Subject: Transportation Consulting Services
Proposed The Sanctuary at Ashland Mills (40B)
10-60 Main Street, Ashland, MA

MDM Transportation Consultants, Inc. (MDM) is pleased to provide you with the following supplemental transportation review comments for the above-referenced project. These comments have been prepared based on review of Proponent's response memorandum prepared by VAI dated February 27, 2025, project coordination meeting with the Town of Ashland department heads on Wednesday, March 12, 2025 via Zoom, and a review of updated Site plans prepared by Bohler Engineering dated March 12, 2025 as identified below. To facilitate response by Proponent, review items requiring response are noted in ***Bold Italic***.

Ashland Tower 1 – HME 104' RMA

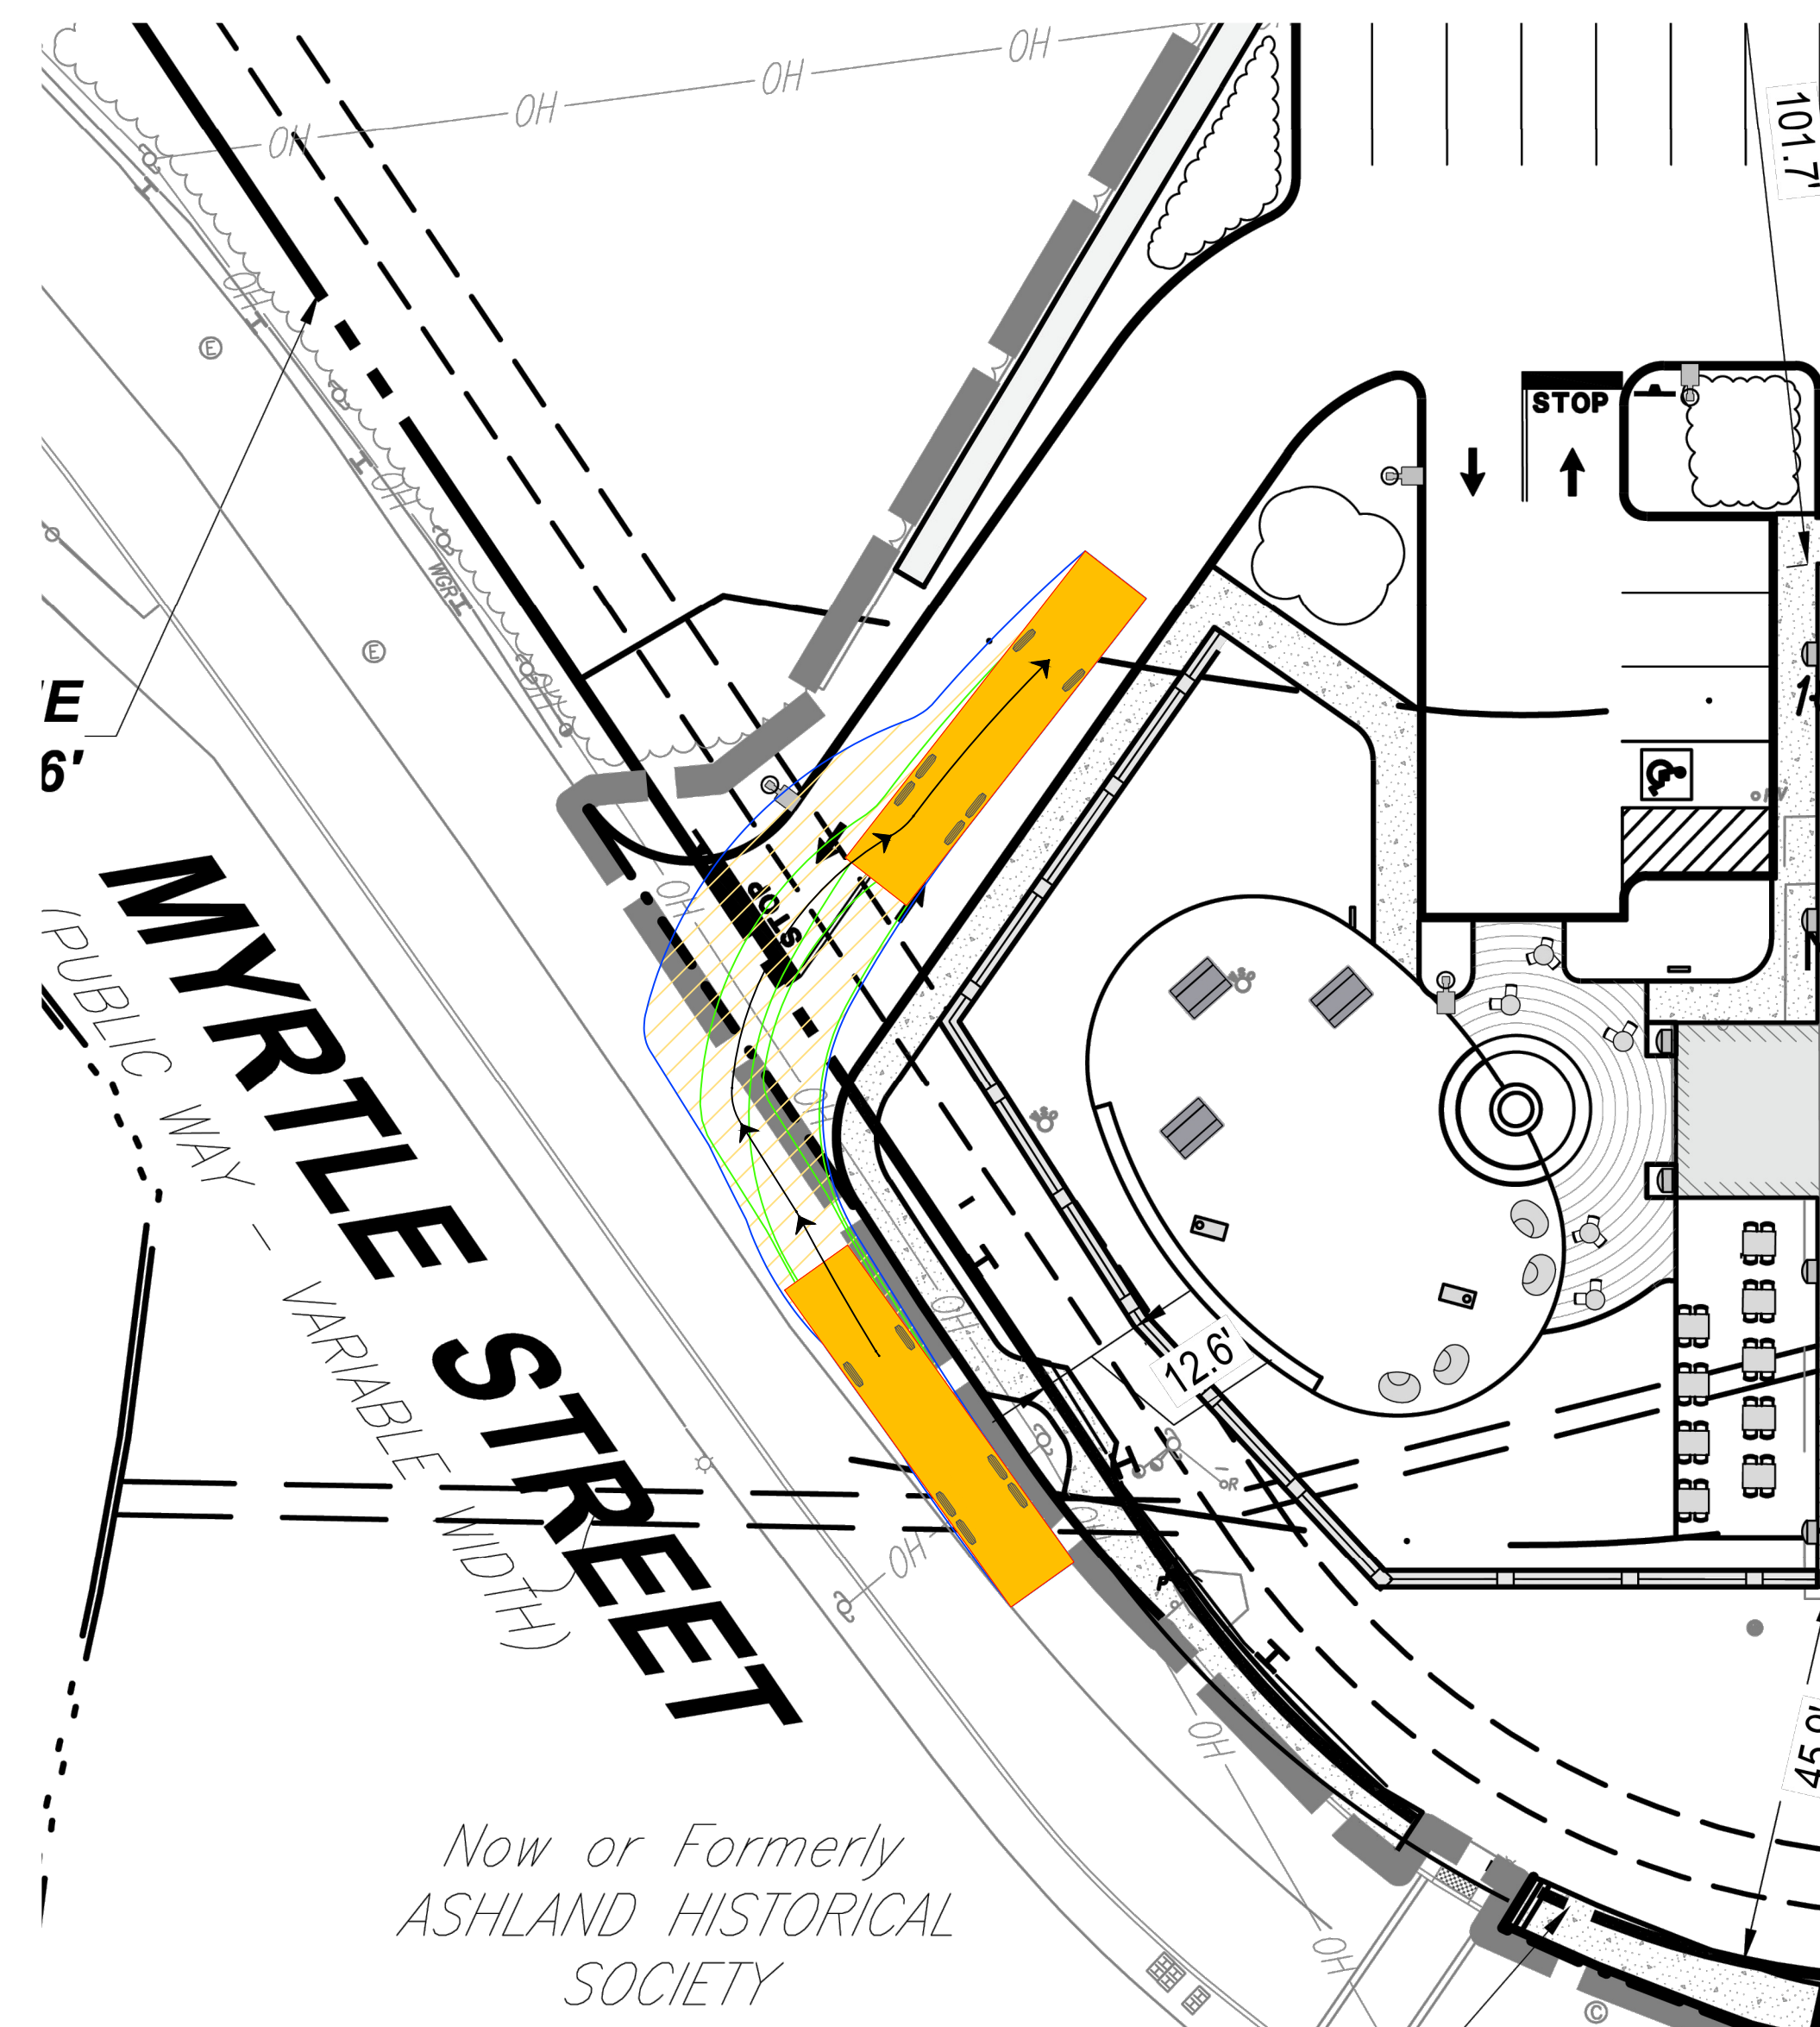
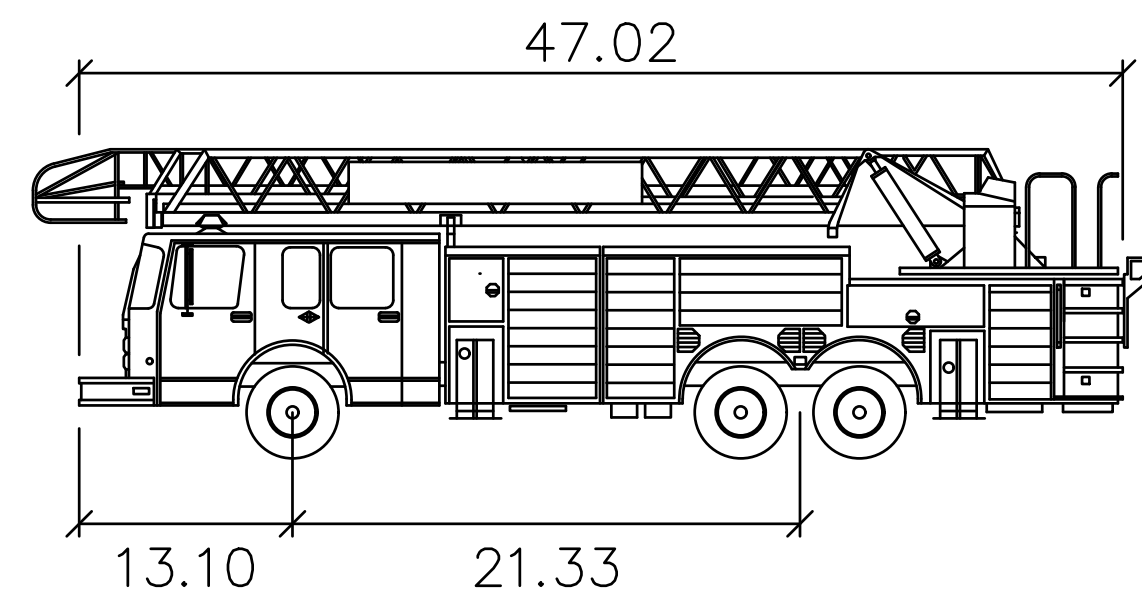
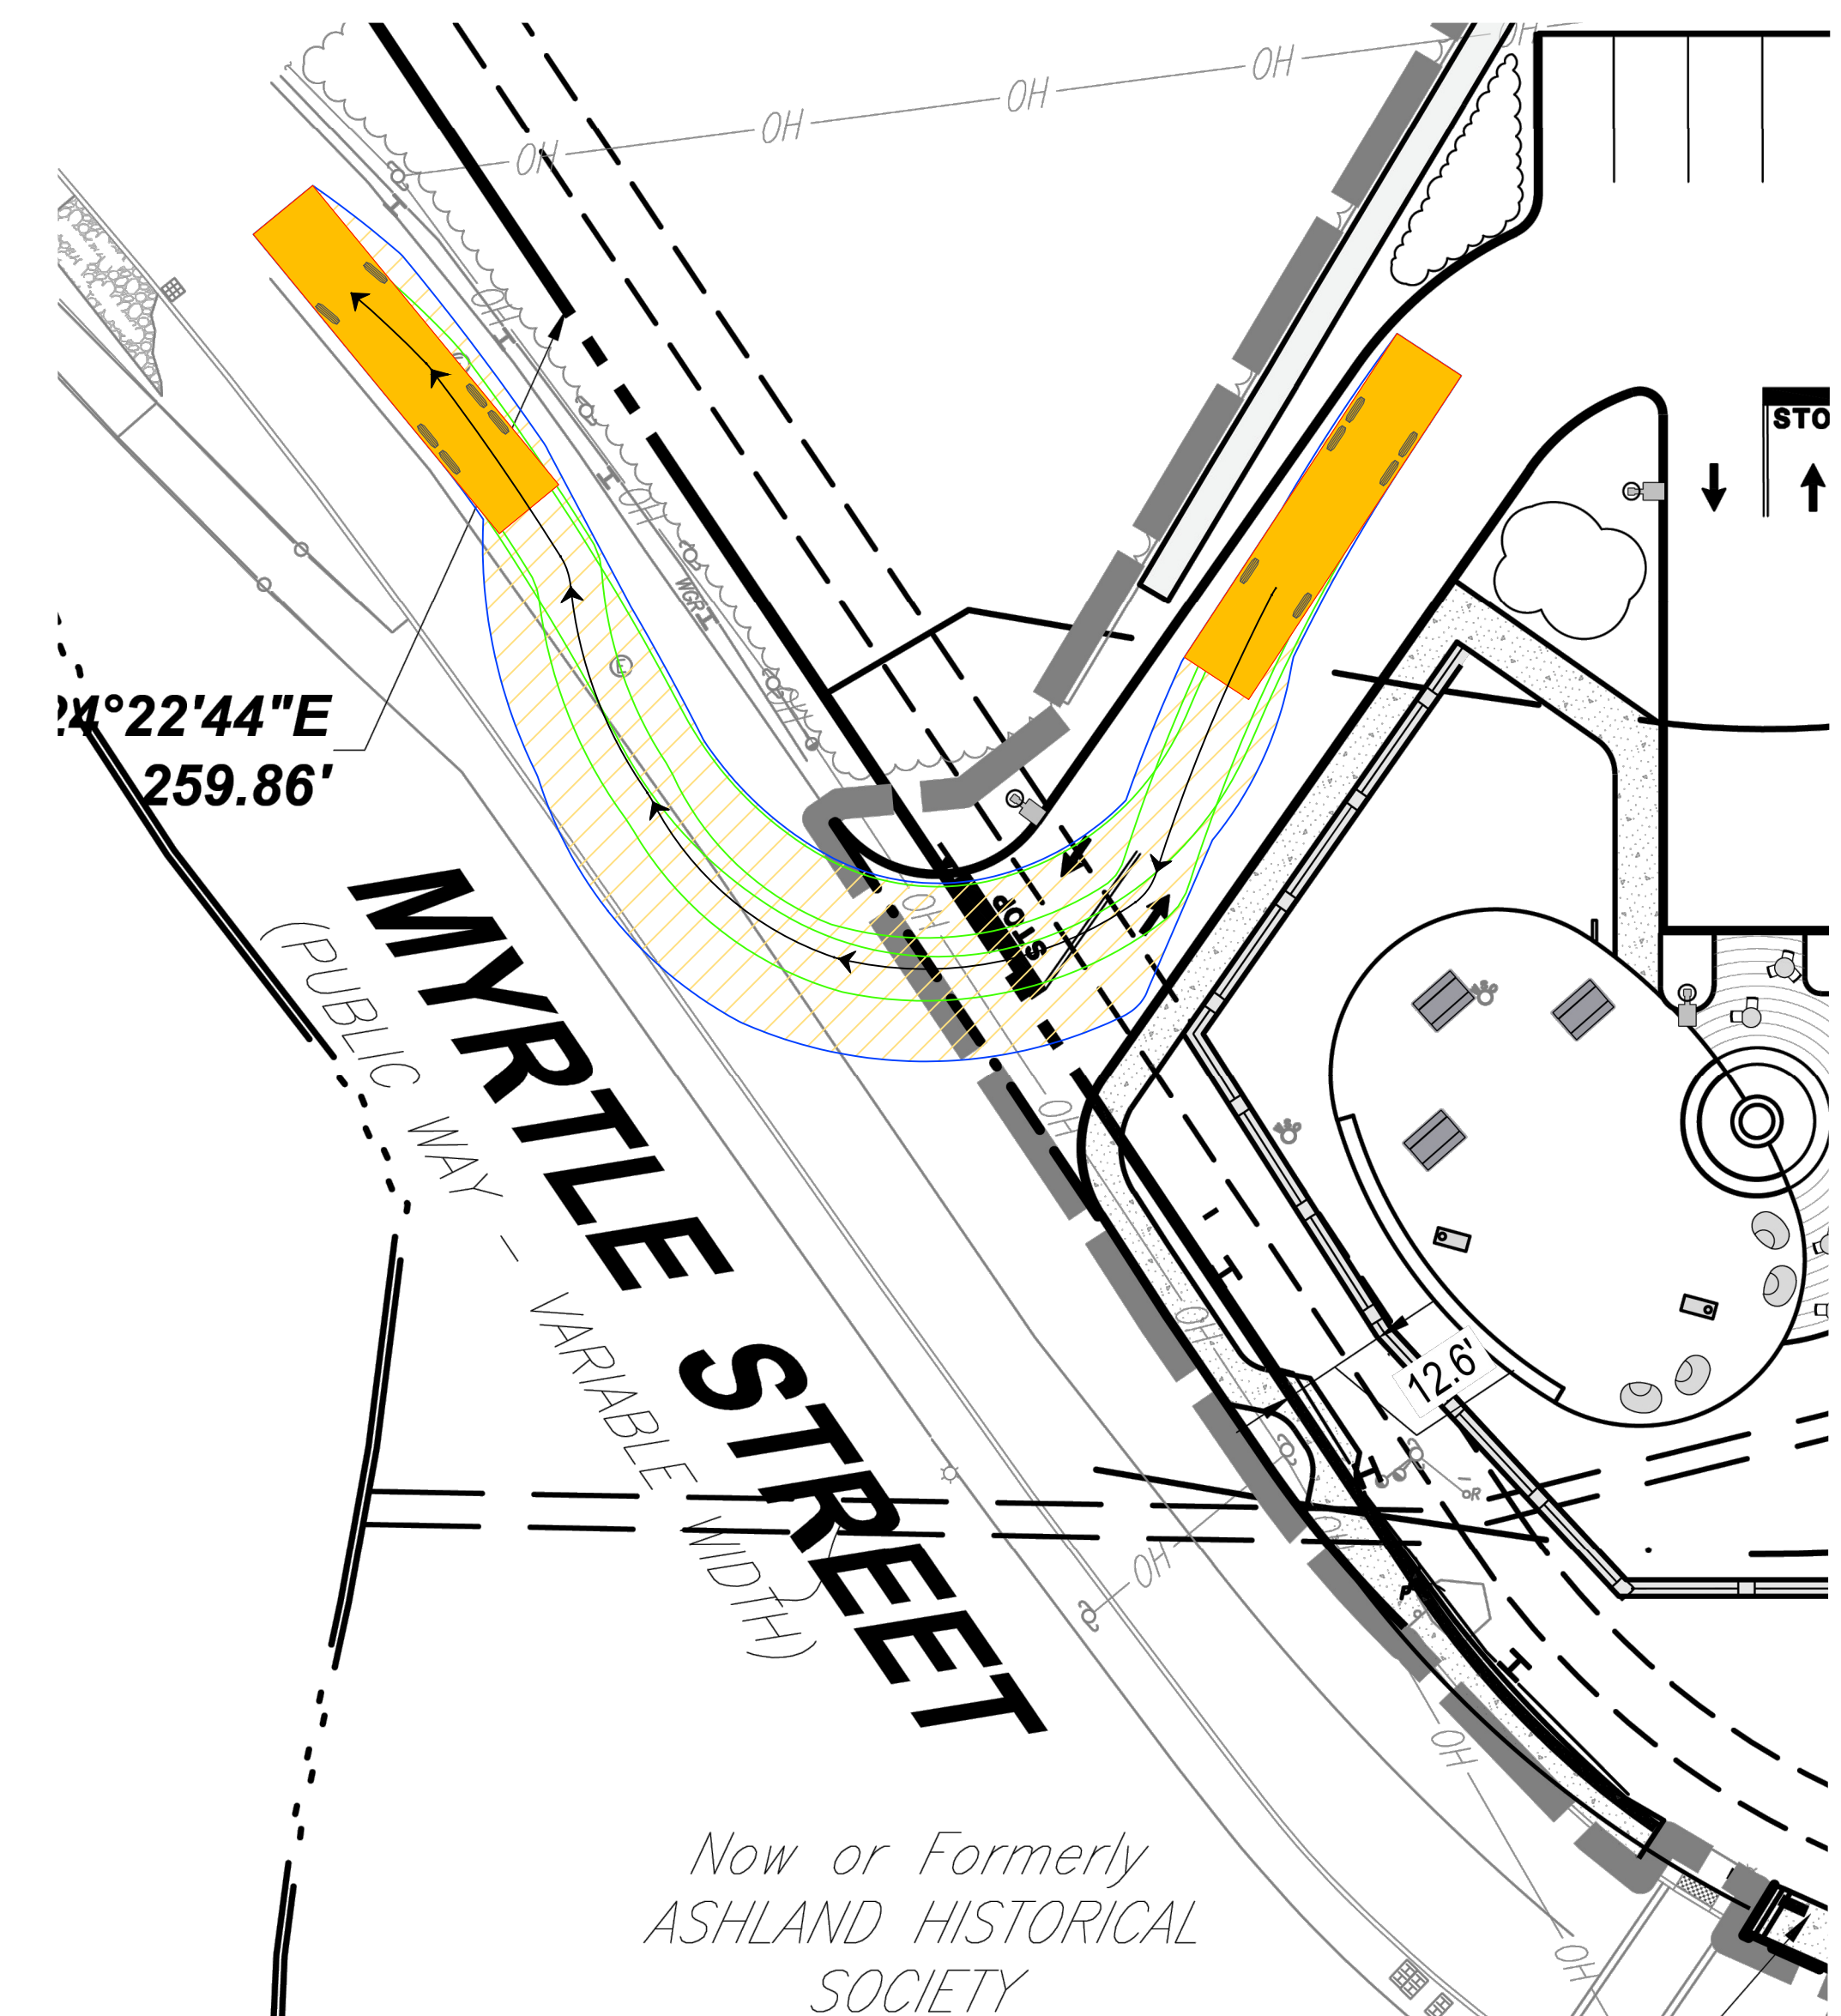
Supplemental Comment: Swept path exhibit for Fire truck dated March 11, 2025 indicates wide sweeps requiring entire driveway width for Site access or egress; no modeling is provided for Myrtle Street right-turn egress (a movement required if concurrent/subsequent response is required to points north of the Site). Encroachment into opposing driveway travel lanes is not consistent with requirements under the NFPA 1 and the Massachusetts Amendments (527 CMR 1.0 Chapter 18) for travel in opposing lanes. Modification of driveway design per Comment 3b and Comment 12e is recommended to properly accommodate fire apparatus vehicle sweeps, reinforce turn restrictions (Main Street driveway) and maximize available intersection sight lines (Myrtle Street).

The Myrtle Street driveway will serve as a primary driveway for the Site given the left-turn restrictions at the Main Street driveway. Based on discussion with the Ashland Fire Department, this driveway will also serve as the sole means of egress for fire apparatus that would need to return to the downtown station after a response or, alternatively, would need to use the driveway for concurrent/subsequent response for other neighborhood locations north of the Site. Accordingly, it is imperative that the design of the driveway properly accommodate vehicle swept paths and maximize sight lines/driveway visibility to ensure safe and efficient maneuvering by fire apparatus at this location.
